IS 2973 (1983): Bicycle Steering Head Assembly (PH Type)
[TED 16: Bicycles]

SPECIFICATION FOR BICYCLE STEERING HEAD ASSEMBLY (PH TYPE)

AMENDMENT NO. 1 NOVEMBER 1986

AMENDMENT NO. 2 AUGUST 1987
TO
IS : 2973-1983 SPECIFICATION FOR BICYCLE
STEERING HEAD ASSEMBLY (pH TYPE)
(First Revision)

FIG. 8 LAMP BRACKET (SCHEMATIC)

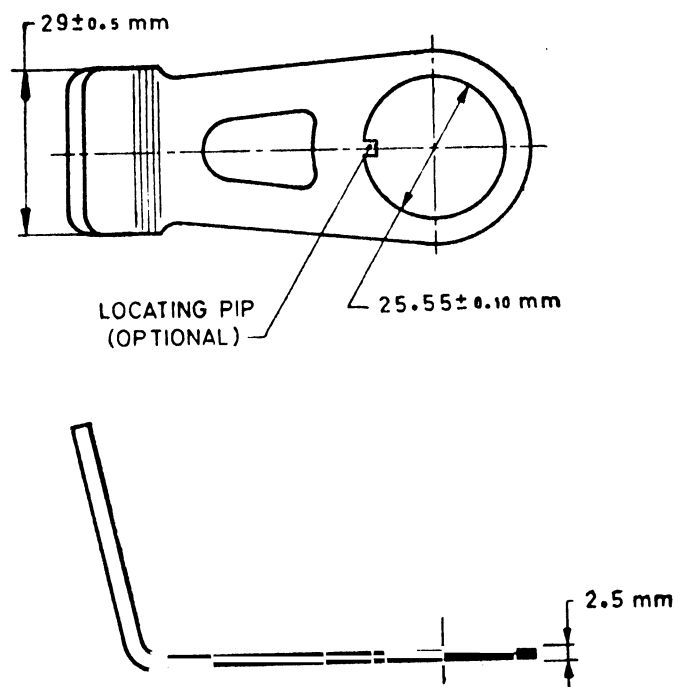
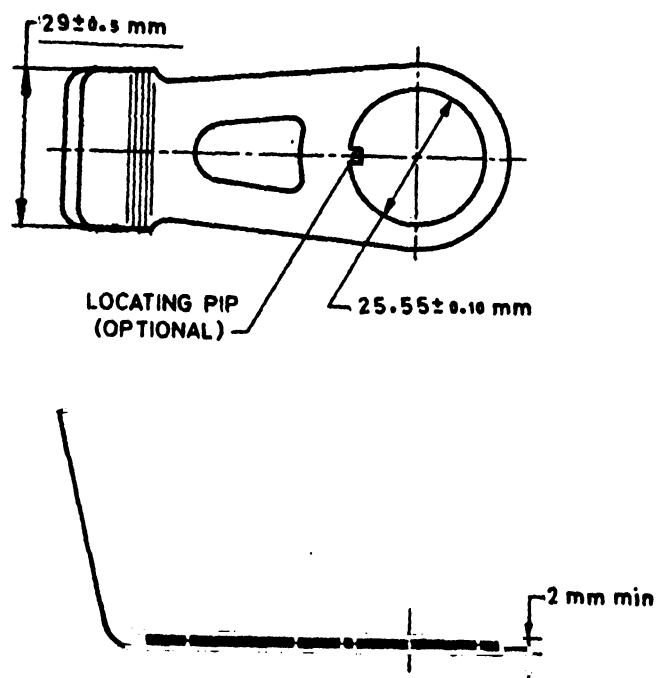
(Page 4, Fig. 8) — Substitute the following for the existing figure:

FIG. 10 ARRANGEMENT FOR LOAD TEST OF LAMP BRACKET

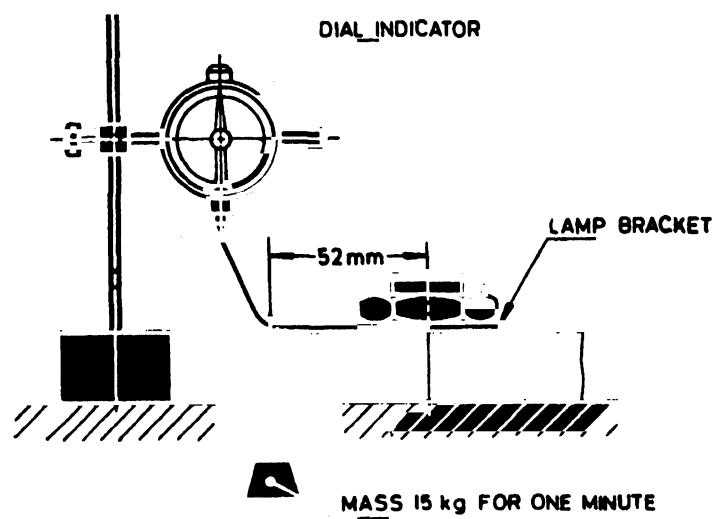
(Page 5, clause 6) — Add the following new clause after 6:

6.1 Lamp Bracket — Lamp brackets shall be subjected to load test. Typical arrangements for the load test have been illustrated in Fig. 10. Test load of 15 kgf shall be applied for one minute. The permissible deflection, at the end of the test shall not exceed 2 mm.
